RFP ADDENDUM

RFP Title: DEPLOYMENT OF PUBLIC ELECTRIC VEHICLE CHARGING STATIONS IN MORDEN, MANITOBA

RFP#: COM-PE-03-2025

Addendum #: 02

AEC EV CHARGING STATION

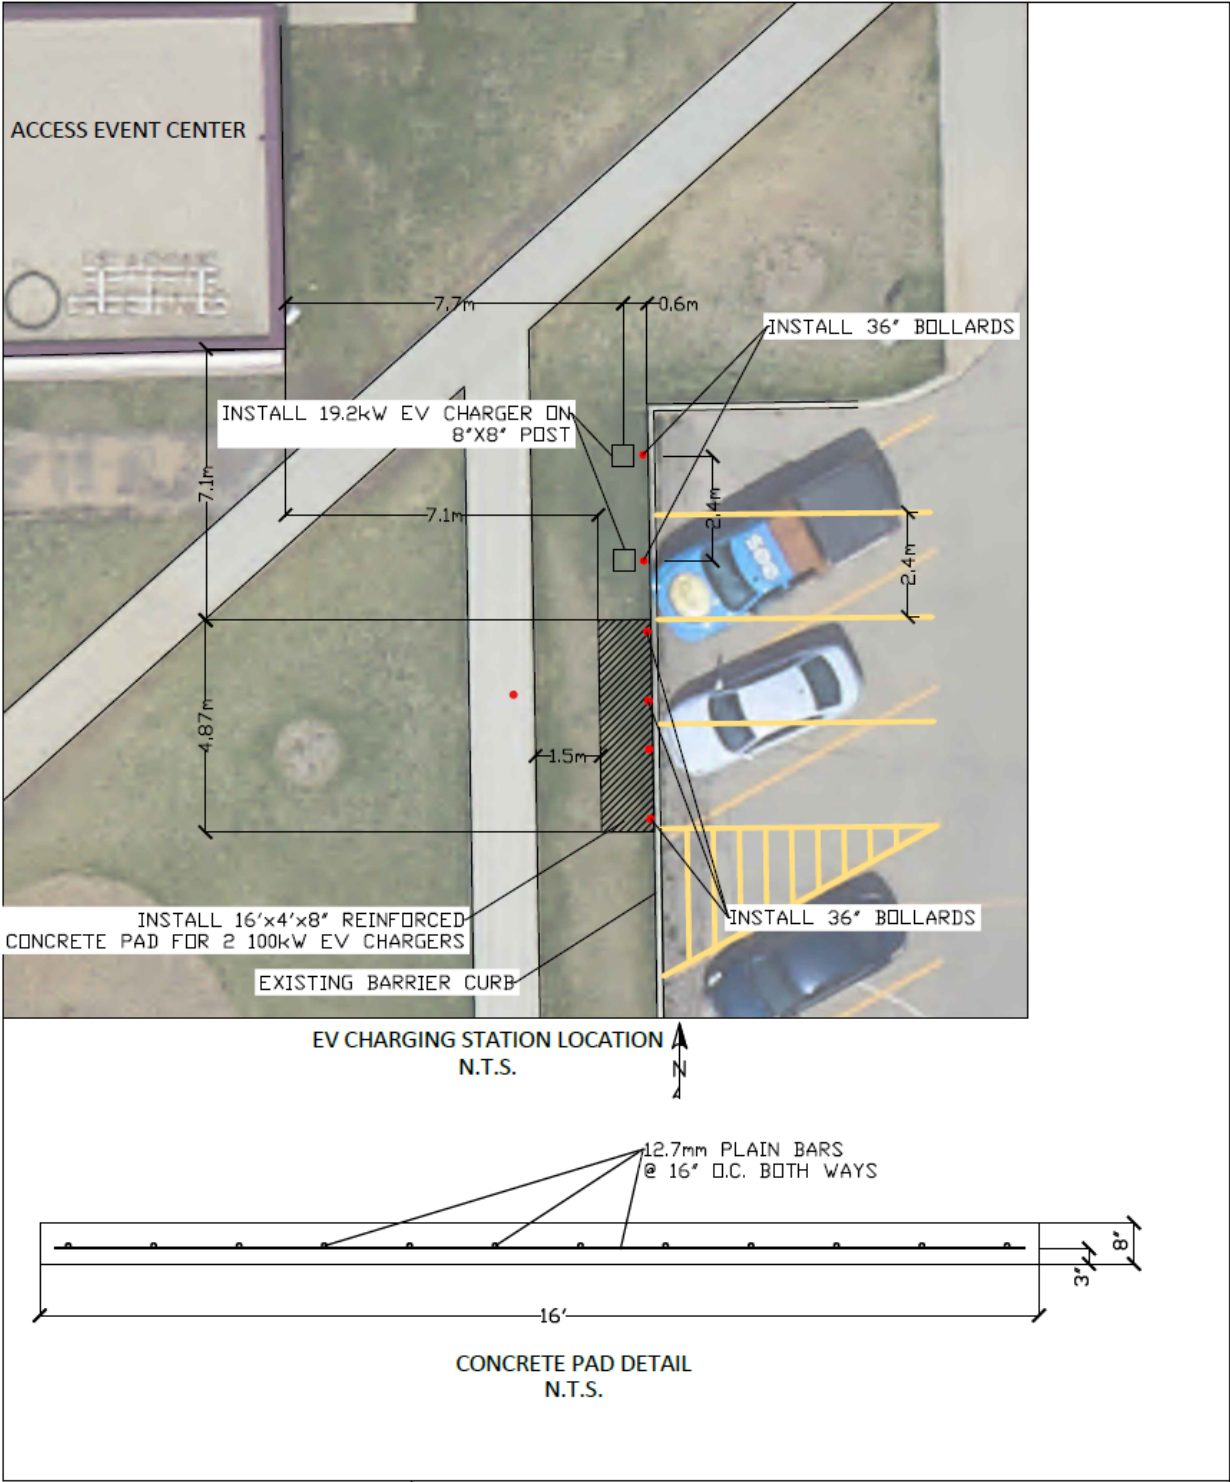
Question-3: Is more clarification available for the alternative location chosen, at the Access Event Centre, 111 Gilmore St? Are there design parameters the City would like to adhere to?

Answer: Layout drawing and details of the concrete pad are provided in the drawing attached to this addendum. However, proponents are free to propose modifications to layout at the same location.
